ORIGINAL
UNITED STATES
NUCLEAR REGULATORY COMMISSION

ADVISORY COMMITTEE ON REACTOR SAFEGUARDS

307TH GENERAL MEETING

DATE: THURSDAY, NOVEMBER 7, 1985

SIMPLIFIED SCHEMATIC OF PALO VERDE CVCS SHOWING SOURCES OF BORATED WATER FOR AUXILIARY SPRAY

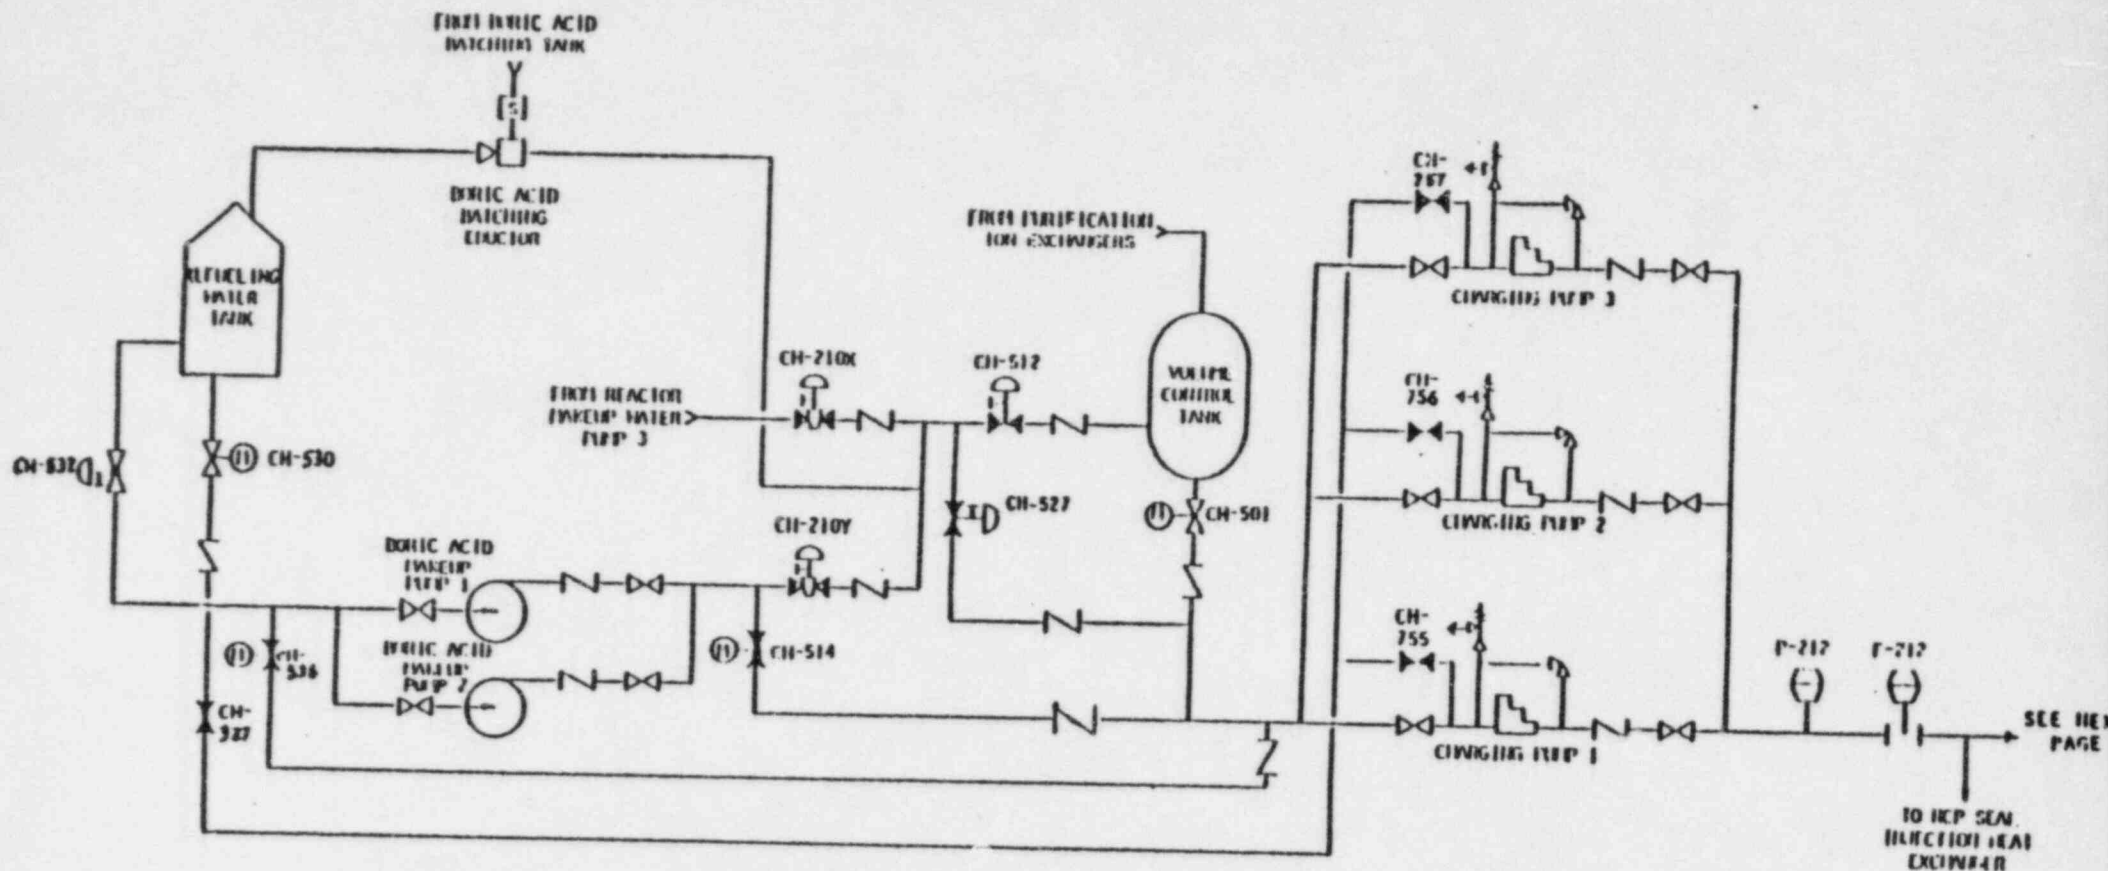
19 MR. EBERSOLE: I would like the committee to ask
20 any questions about the diagram. I would just like you to
21 notice the dual suction, the primary suction, the chosen
22 suction, the amount of the value control tank rather than
23 the refueling water storage tank. However, the head suction
24 is from the refueling water storage tank.

18 MR. EBERSOLE: As a matter of fact, if the one
19 under the right tank stays open, that suction will override
20 and defeat the suction you are trying to encourage, is that
21 correct?

VALVE POWER SUPPLY CHANGE

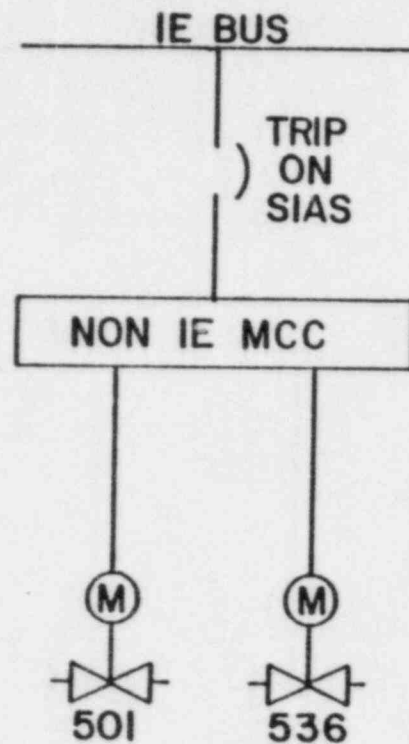
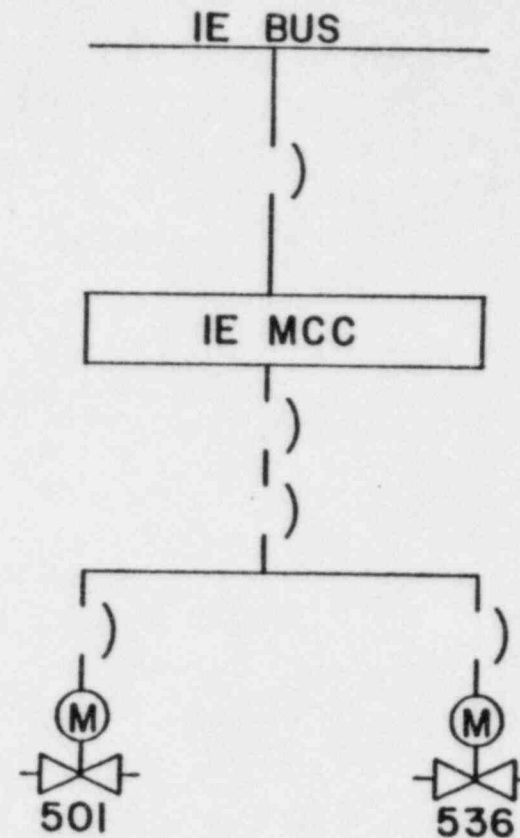
4 MR. WYLIE: I still have a question on 501 and
5 536.

12 Before you made that change, you had them on
13 individual circuits, completely independent except for the
14 control center. They came from a common mode control
15 center, and now you show them tied together.

17 MR. QUAN: As far as I recall, with the
18 modification there is the same degree of independence as
19 there was before -- as far as I recall.

CHANGE ENSURES OPERABILITY FROM CONTROL ROOM AFTER SIAS AND LOP SUCH THAT SUCTION COULD BE ALIGNED TO RWT FROM VCT.

PRESSURIZER VENT PATHS

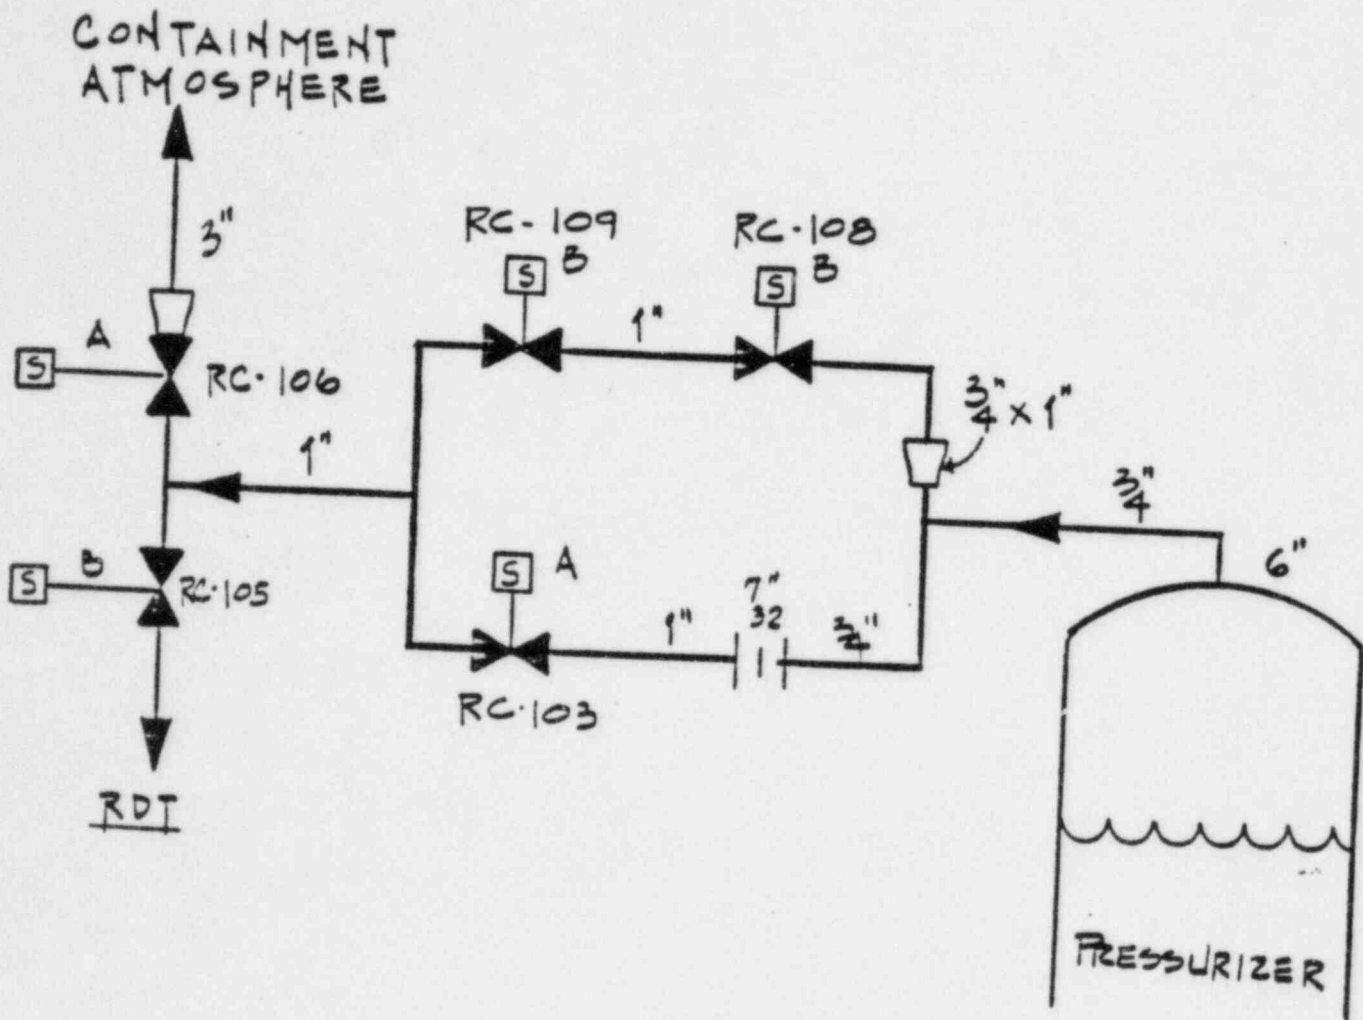
11 Do you normally plan on venting to atmosphere or
12 to the reactor drain tank?

8 MR. EBERSOLE: I see. There is a code change to
9 a lower grade pipe. So then you are subject to inadvertent
10 steam blowdown if you have a spurious opening of that, and
11 you run that commercial risk, whatever it is.

19 MR. EBERSOLE: Although there is a code change in
20 that one-inch line, that doesn't mean there is any reason to
21 believe it wouldn't hold 2250, or is there?

6 MR. HAYNES: Not shown on the drawing is a code
7 change in the piping.
